**Re: Hardware change notice. Intel Motherboard DG41TY.**

This is an official hardware change notice. To stay competitive in the constantly changing industry, i<sup>3</sup>DVR will be changing the motherboard model for the entire line of Compact DVRs, including SRX-Pro Ultra Lite, SRX-Pro Lite and SRX-Pro Hybrid models.

Figure 1. - Intel DG41TY motherboard

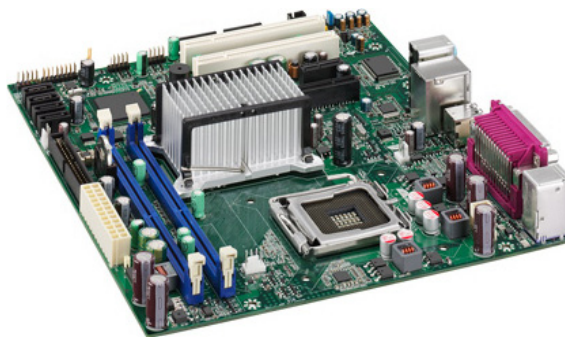
Due to our previous positive experience with Intel line of motherboards, we will continue using the Intel brand. Starting June 1<sup>st</sup>, 2009 all Compact DVR models will be switching to **Intel DG41TY** motherboard model from the current *Intel DQ965GF*.

The new motherboard model, **Intel DG41TY**, meets all the requirements of our compact DVMS line. This motherboard features a total of 4 Serial ATA (SATA) inputs and a total of 8 USB 2.0 ports (4 external, 4 internal). *Intel DG41TY* motherboard supports up to 4GB of RAM and features 2 conventional PCI and 2 PCI Express bus connectors.
